# Final Rulison Path Forward

June 2010

### **Responses to Comments on the Draft Rulison Path Forward**

Figure 4. Activity of Radionuclides in Gas from the Production Tests on the Reentry Well (Note that the scale for carbon-14 is on the right side of the graph.)

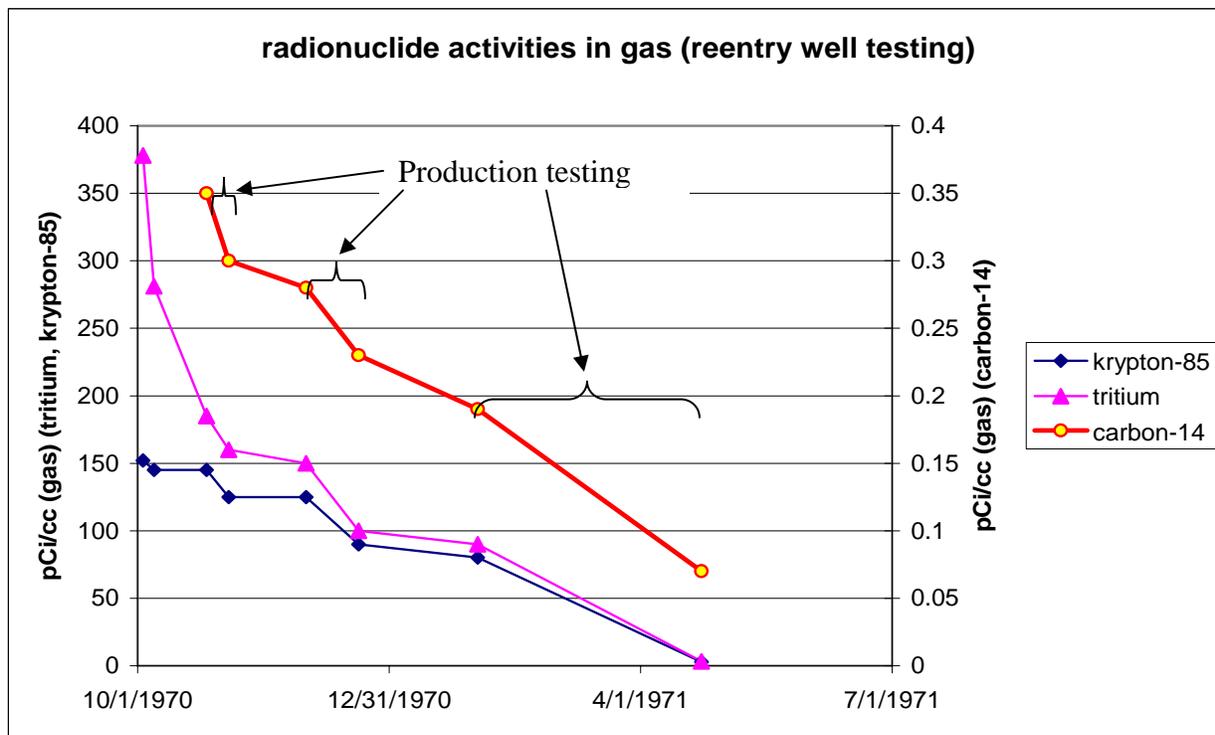
21	Document-Specific by CDPHE 3	Section 2.1 notes that more Carbon-14 was released in the production test than was predicted by the pre-blast modeling of the radionuclide production from the blast. At first glance, this appears to indicate that the pre-blast modeling could have underestimated the amount of radionuclides generated by the blast. If so, the calculation of the radionuclide material remaining in the blast zone following the production test could be significantly different from that used in the modeling supporting the current assessment of migration potential.	<p>Table 1 in the Path Forward lists a revised (corrected) estimate of the curies of carbon-14 generated by the test. This value is only slightly less than the observed number of curies removed during production testing.</p> <p>Note that estimates of radionuclide inventories are, by their nature, likely to differ from actual inventories. One of the benefits derived from the post-test gas production and flaring was a more accurate estimate of the amount of each radionuclide produced by the test. The source term used in the DOE model of tritium transport was based on the results of the reentry well testing.</p>
